SIB 41 03 22

WATER INGRESS INTO VEHICLE DURING CAR WASH

E-Series	Model Description
G42	(2 Series Coupe)

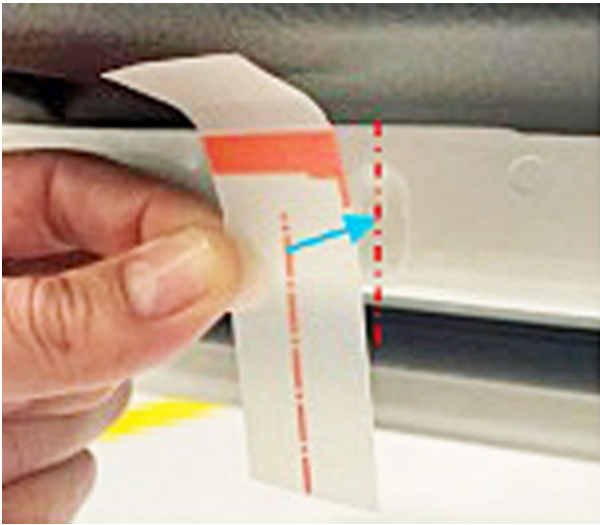
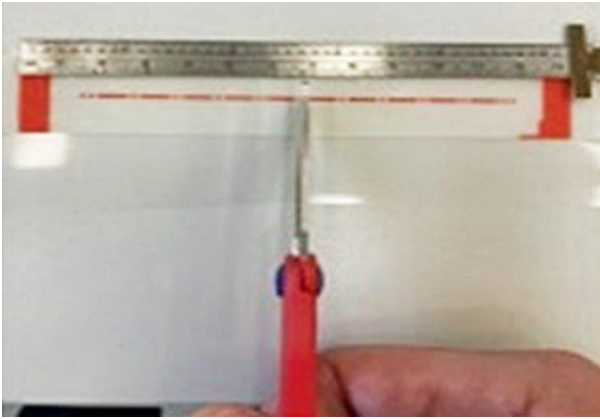
Due to high water pressure, water ingress is possible through the driver and/or passenger door. Water can penetrate through 2 small gaps between the door bottom and the side sill.

General location of the two gaps along the underside of the door shown (arrow). These can be viewed by looking up at the underside of the door.

Close-up of one of the gaps.

Place protection foil on the depressed areas of both doors.

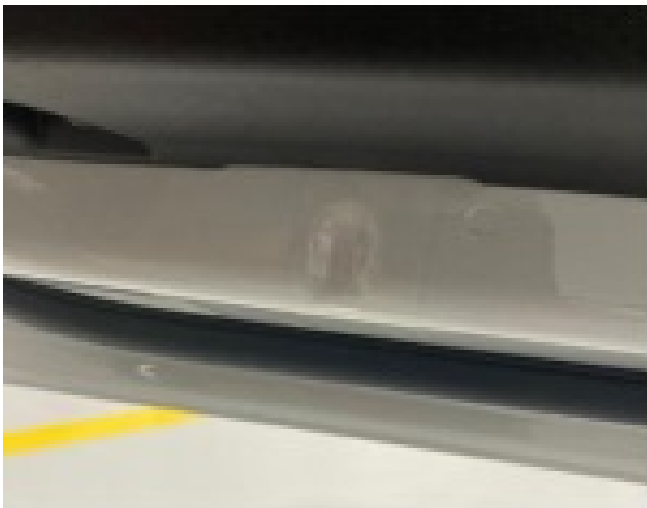
3. Align the red line of the foil to the center of the depressed areas of “a” and “b”.

4. Proceed to apply the foil on the depressed areas and assure a flat condition. **Note: Please ensure a flat installation. No bubbles wrinkles, and/or wrong application during the installation.**
